牌子	PHILIPS	型号	BM5B	工程师审核	开发品管部 审核	项目	丝印示意图
编制	廖绮萍	美工审核		项目经理审核	批准	日期	2015-7-3

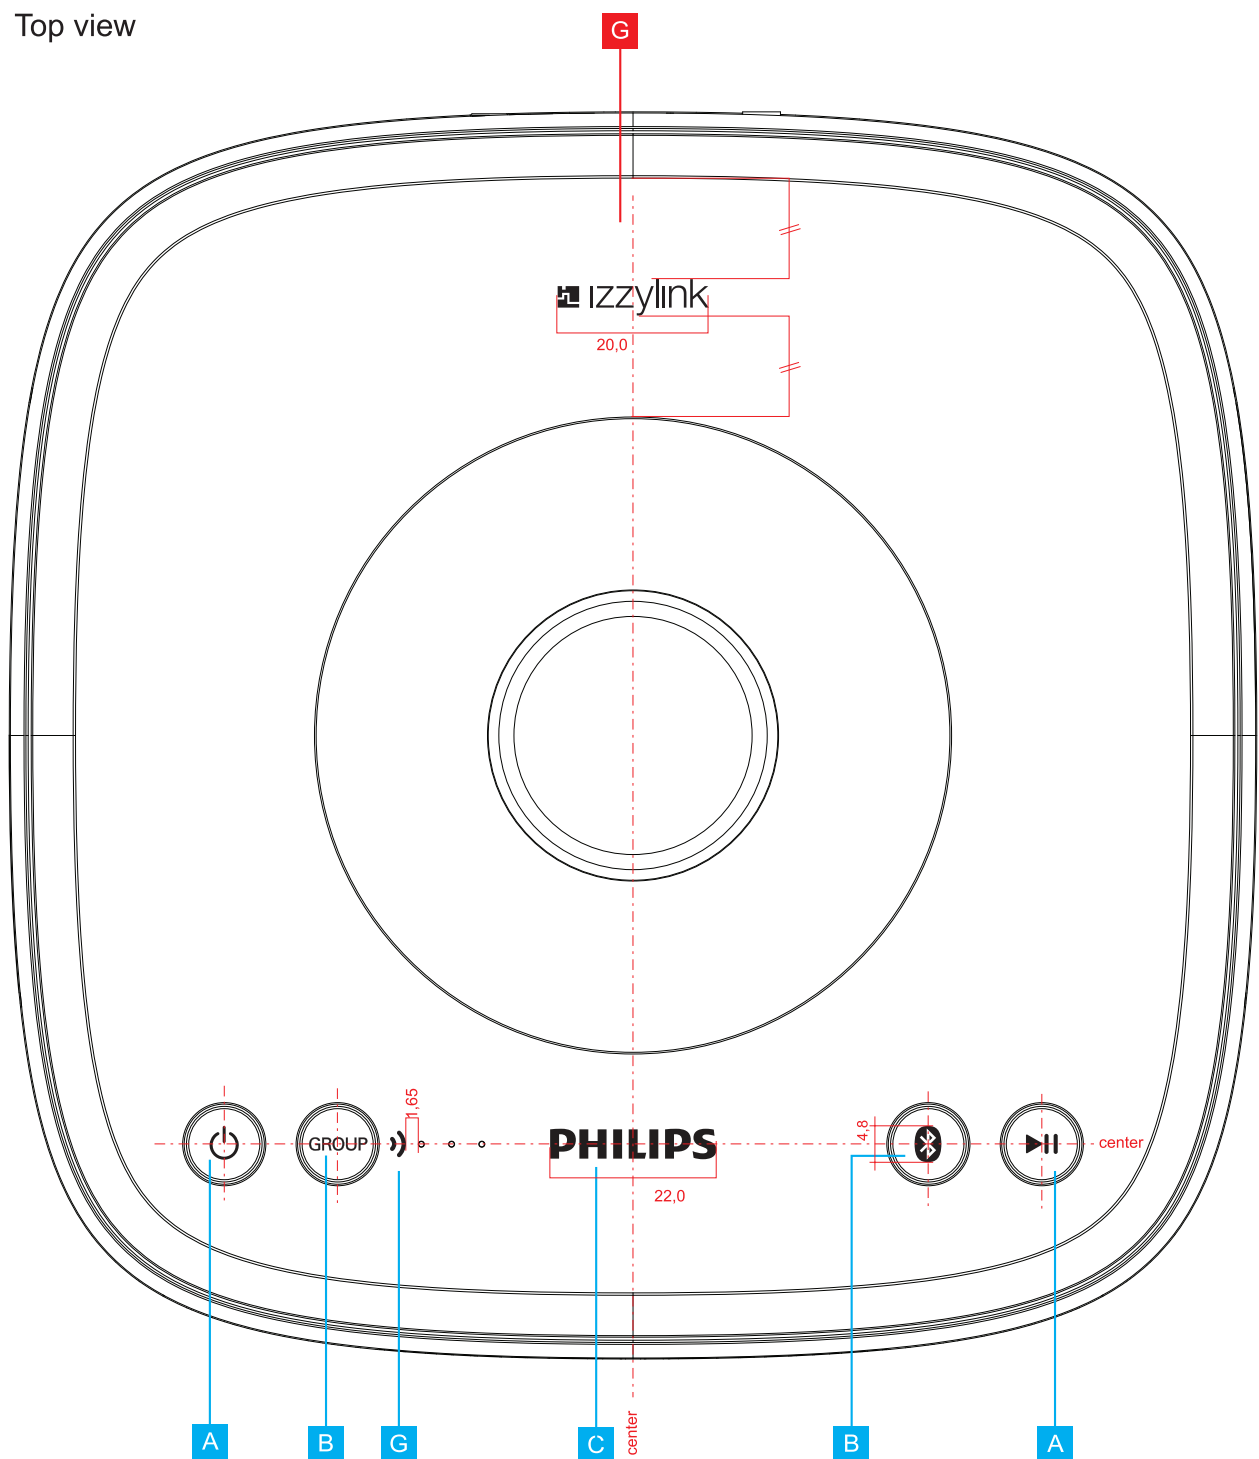
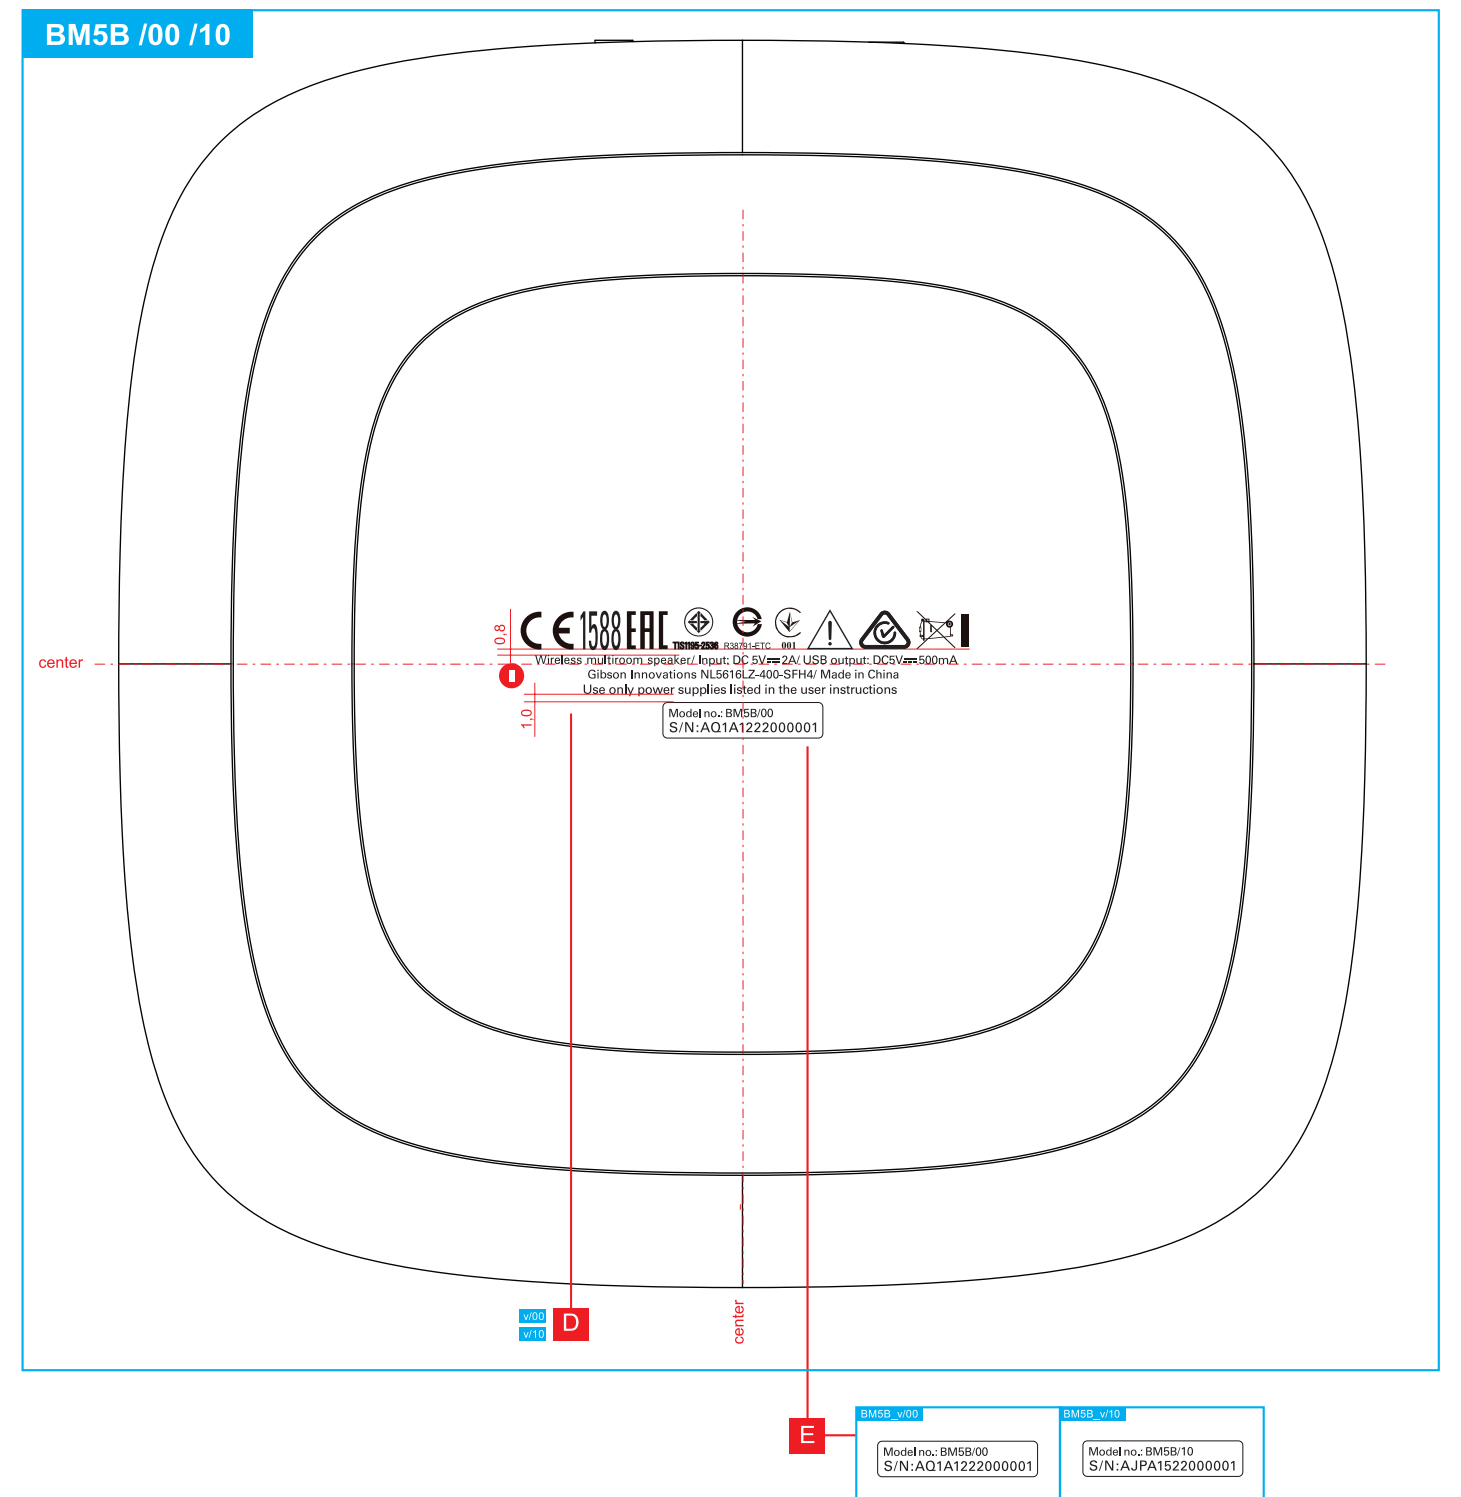
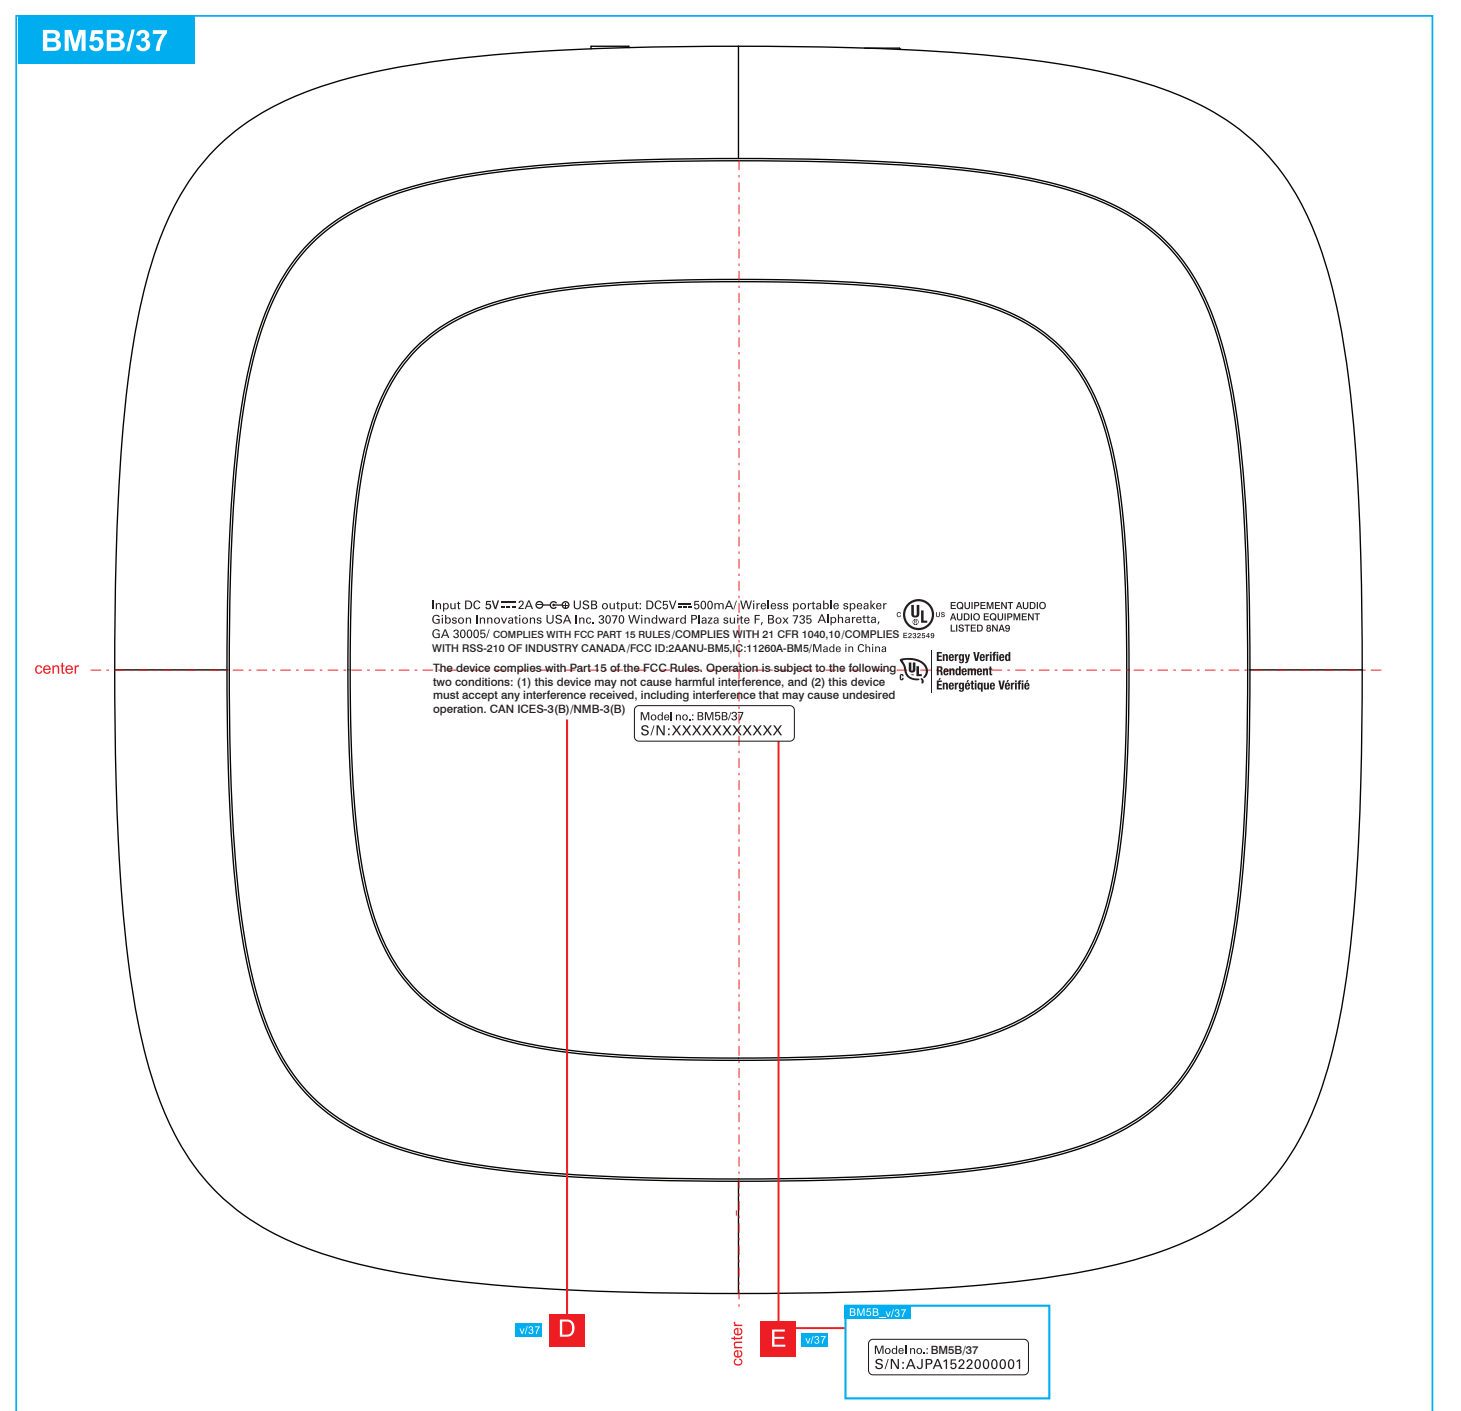
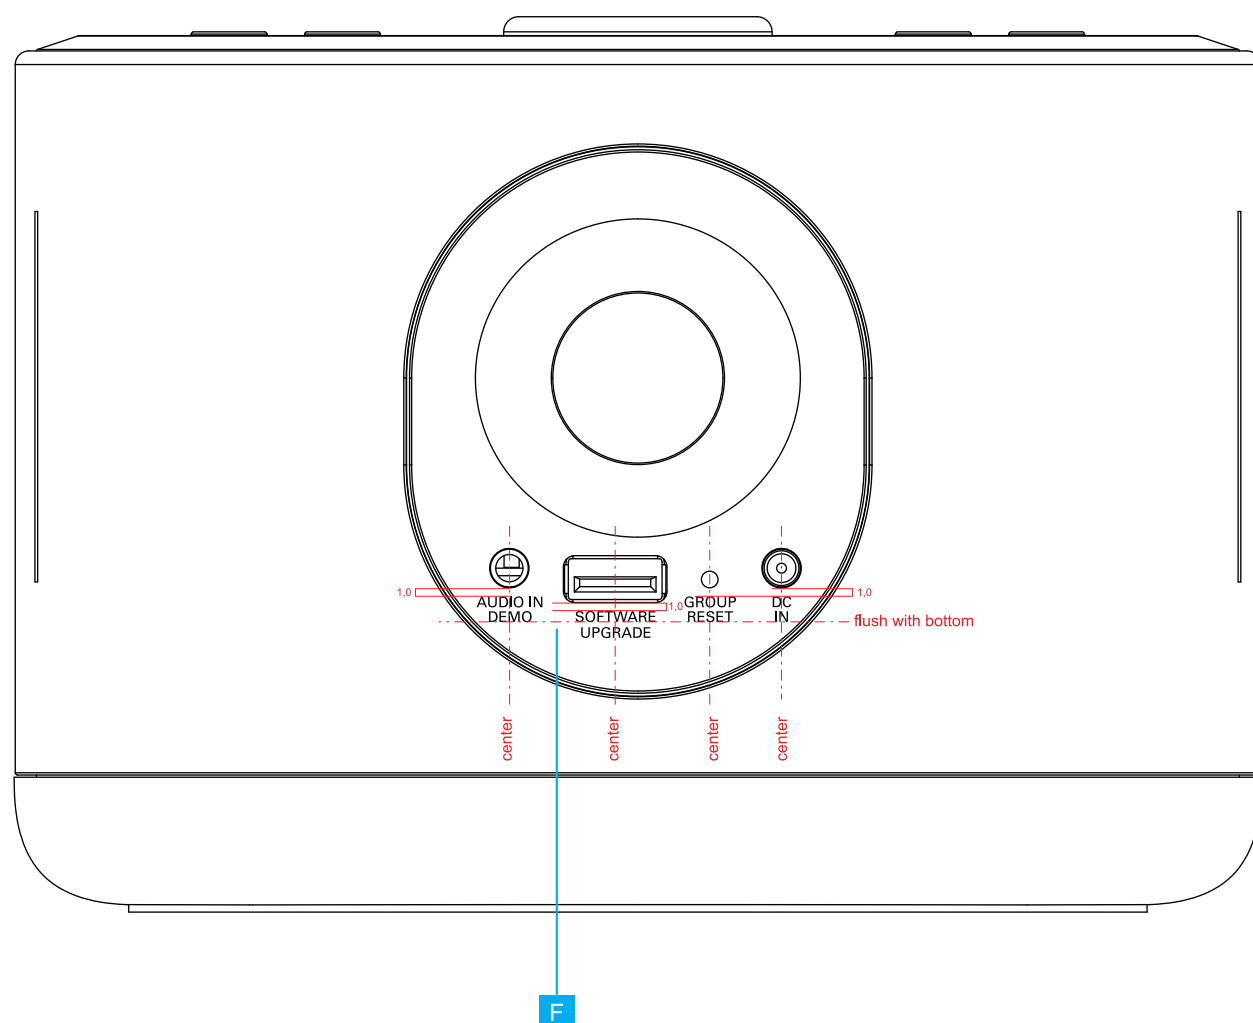
PART	COLOUR	TECHNIQUE	CHANGES / REMARKS	VER
A Playpause symbol ▶ / ◂	--	Laser engraving, ref to MUS #5/ #7/ #9	Silkscreen graphic and laser etch graphic share same grey tone V4.0: added POWER icon graphic/ changed into laser engraving	4.0
B Functional graphic Ⓞ GROUP	--	Laser engraving, ref to MUS #5/ #7/ #9	V4.0: shifted POWER with ▶ icon, no back lit	4.0
C PHILIPS branding	PMS silver	Silkscreen metallic printing	--	1.0
D Approbation information	PMS cool grey 7C	Silkscreen printing	V2.0 updated graphic as per briefing V4.0: updated approbation info /00 and /10 with supplier input V5.0: updated USB output voltage V6.0: Update logo with supplier input	6.0
E S/N sticker	PMS cool grey 7C	Offset printing/ material refer to MUS #22	V4.0: added /10 label; moved CTN to label V6.0: Update sticker size with supplier input	6.0
F Functional graphic	PMS cool grey 8C	Silkscreen printing	V3.0 updated Upgarde Connector graphic as per input V4.0: updated AUDIO IN DEMO/ GROUP RESET graphic	4.0

G Signal strength icon & izzylink	PMS cool grey 8C	Silkscreen printing	V2.0 updated graphic as per briefing V4.0: added feature icon V6.0: Update feature icon izzylink	6.0
